June 17, 2013

Addendum No. 2 for Bidding Documents for the:

Hazel Park High School Storage Building

Hazel Park, Michigan

1/AD1

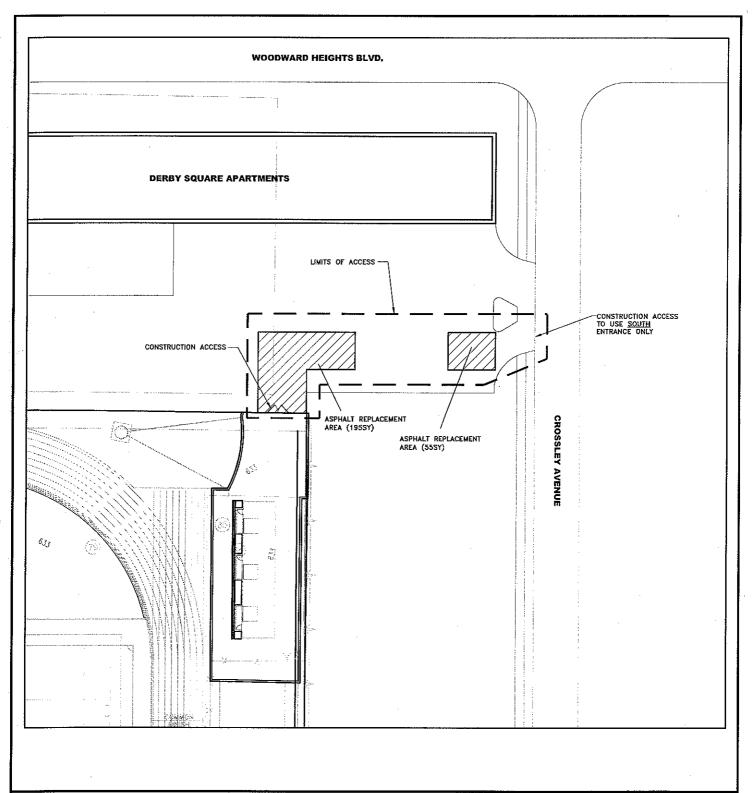
- A. Refer to attached sketch 1/AD1 delineating the area of access to the site through the neighboring property and the base bid pavement replacement area of 250 SY (cost to be shown on bid form). Refer to section 00 72 00 General Conditions Article 3.13 for additional requirements.
- B. Contractor to eliminate removal of existing asphalt, stone base and excavation of lawn area as outlined on Detail #2 — Existing Conditions and Demolition Plan from scope of work. Asphalt removal and excavation of lawn completed by others.
